PLANNING COMMISSION
Regular Meeting
Monday, August 7, 2017
7:00 PM
Christine Nuernberg Hall

Agenda

TO: Planning Commission
FROM: JAC ZADER, ASSISTANT DIRECTOR COMMUNITY DEVELOPMENT
DATE: August 4, 2017
SUBJECT: Raposa Design for Brixmor SPE I LLC. The applicant is seeking conditional use grant amendment approval to allow for an expansion to the outdoor dining patio at 11046 N. Port Washington Road (Chancery).

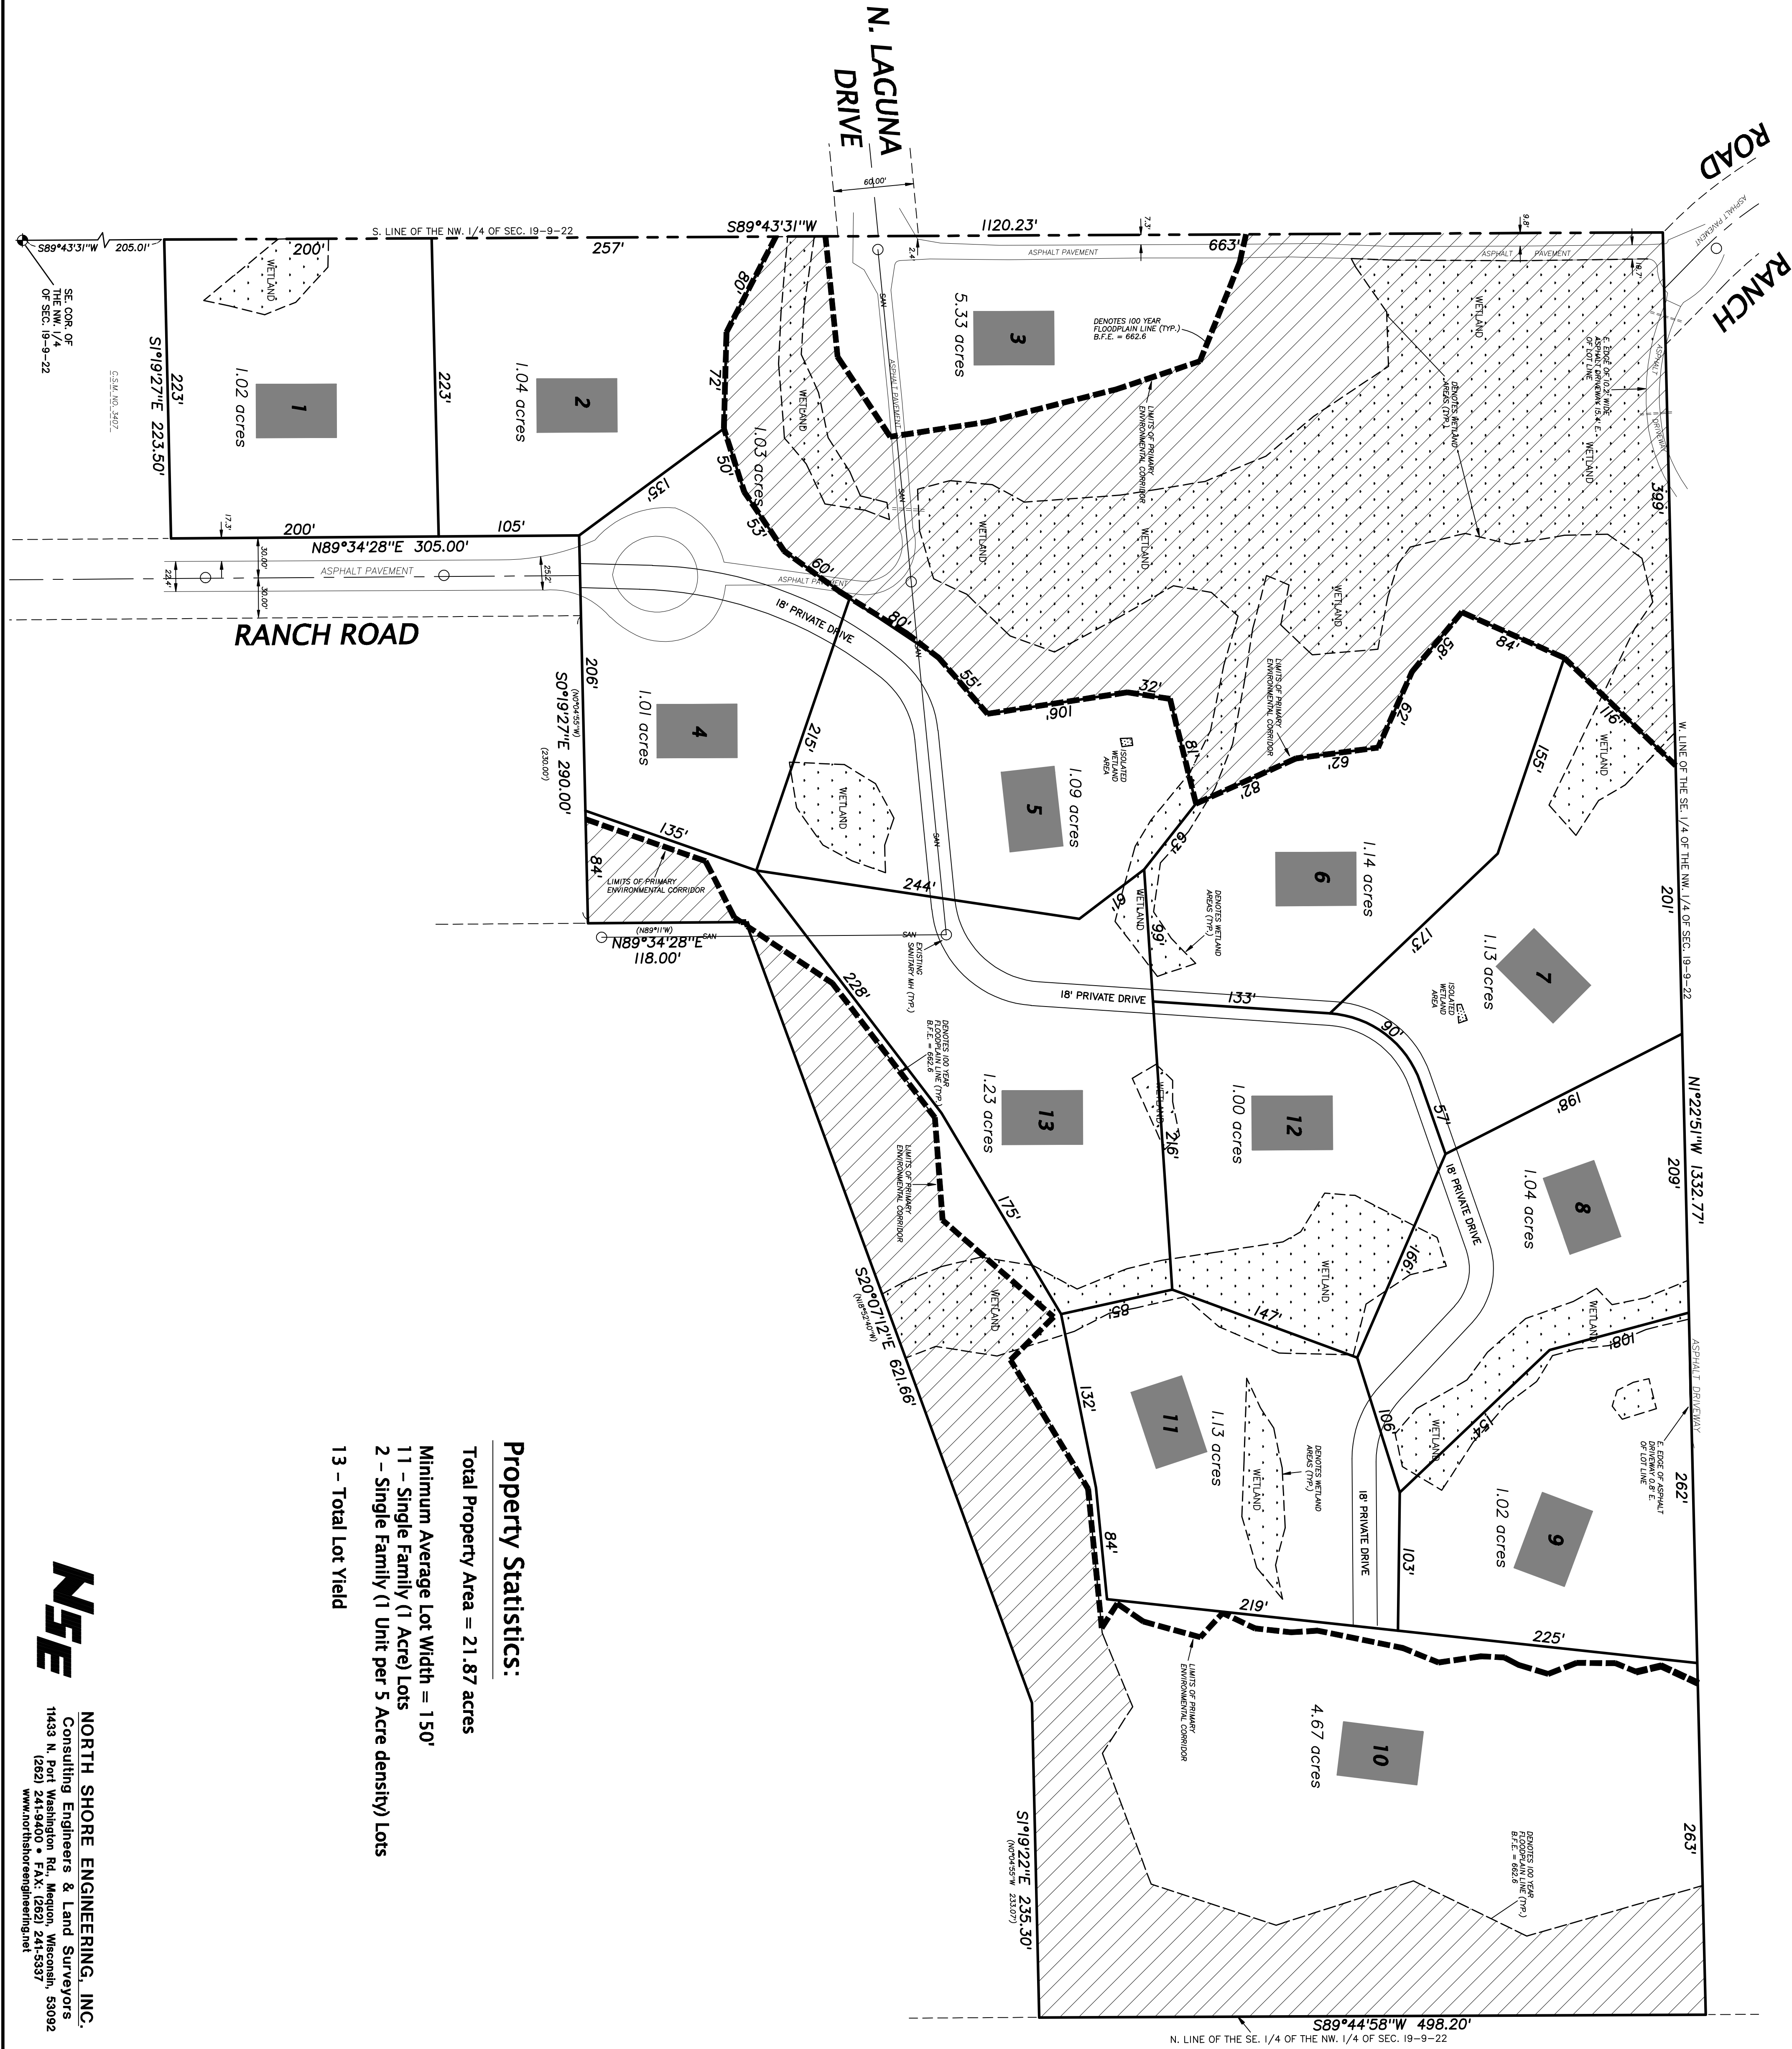
The concept plan shows thirteen lots surrounded by common open space. There is walking trail around the perimeter of the property that will connect to the existing asphalt trail that runs through the property. The proposed plan shows two storm water ponds being created for the development. The site contains woodlands, floodplain, wetlands and Primary Environmental Corridor. The wetlands have been delineated and have received concurrence from the DNR. The Southeast Regional Planning Commission (SEWRPC) has reviewed and approved the environmental corridor location as shown on the concept plan for the development.

The conceptual plan details thirteen lots near Ranch Road and Laguna Drive. The concept plan includes a lot off of Laguna Drive and 12 lots on Ranch Road. Ranch Road is proposed to be extended and is proposed to include a cul-de-sac. The roadway should be designed to city standards and dedicate a 60-foot right-of-way. There is a proposed private drive serving lots 10 and 11. Private drives are limited to serving no more than four lots. Laguna Drive dead-ends into Lot 1, a turnaround is required.

The concept plan provided does not include the footprint of buildable area for each lot, nor does it include an accurate depiction of the existing utilities. Both are requirements of preliminary plat approval.
